# CAMBRIDGE DISCOVERY PARK

**BUILDING 400, 500 AND 600 AND GARAGE B SUPPLEMENTAL FILING -  
SEPTEMBER 24, 2014**

**RESPONSES TO QUESTIONS  
FROM SEPTEMBER 2, 2014 PLANNING BOARD HEARING**

Perspective from Route 2 including hotel sign

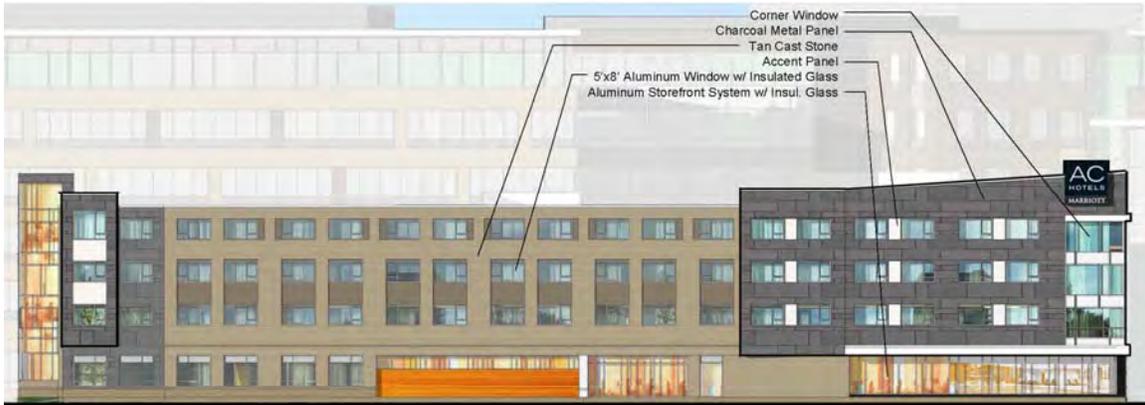
There were several questions regarding the proposed hotel signage. The hotel is set back from the Arlington line such that any new signage on the hotel would be located entirely in Cambridge. The proposal is for a single 10ft. by 10ft. sign, fully compliant with the Cambridge Zoning Ordinance, facing Route 2 and shown in the enclosed image. With respect to the existing sign located in Arlington, the only change to that sign would be the addition of the hotel tenant name (as would be the case for any other new tenant in Discovery Park) – a change that does not require any alteration of the physical dimensions of the sign itself.
